Access Compliance Report

Public Rights-of-Way

(Curb Ramps)

Intersection ID: N/A	Main Street: S BREVARD ST	Cross Street: E 4TH ST	Location:	N
ADA ID: 84494F1050F3	Ramp Type: Perp	Initial Pass/Fail: Fail	Overall Compliance: No	Severity Score: 10
Codes/Mitigation Info/Possible Solution		Field Measurements/Component Compliance

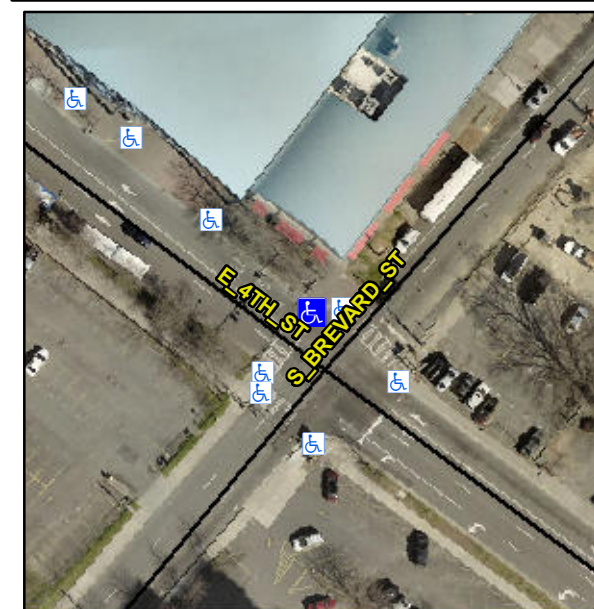
R304.5.1, R304.5.3

Compliance	Description	Data	Compliance	Description	Data
N/A	Ramp Length (in)	40.0	Yes	Ramp Slope (%)	7.0
No	Ramp Width (in)	47.0	No	Ramp XSlope (%)	3.9
N/A	Flare Type LT	N/A	N/A	Flare Type RT	N/A
N/A	Flare Slope LT (%)	N/A	N/A	Flare Slope RT (%)	N/A
N/A	Flare Traversable LT?	No	N/A	Flare Traversable RT?	No
N/A	Landing Length (in)	N/A	N/A	DWS Provided?	N/A
N/A	Landing Width (in)	N/A	N/A	DWS Contrast?	N/A
N/A	Landing Slope (%)	N/A	N/A	DWS Length (in)	N/A
N/A	Landing X Slope (%)	N/A	N/A	DWS Full Width?	N/A
N/A	Landing Curb? (Y/N)	N/A	N/A	DWS Offset (in)	N/A
N/A	Shared Landing?	N/A			
N/A	Gutter Ponding?	N/A	N/A	Gutter Slope (%)	N/A
N/A	Gutter Lip Ht (in)	N/A	N/A	Gutter X Slope (%)	N/A
N/A	Painted X Walk1?	Yes	N/A	Painted X Walk2?	N/A
	X Walk 1 Direction	To SW		X Walk 2 Direction	N/A
N/A	X Walk 1 Width (in)	111.0	N/A	X Walk 2 Width (in)	N/A
	X Walk 1 Slope (%)	3.2		X Walk 2 Slope (%)	N/A
	X Walk 1 X Slope (%)	2.8		X Walk 2 X Slope (%)	N/A

Remove & Replace Entire Ramp.
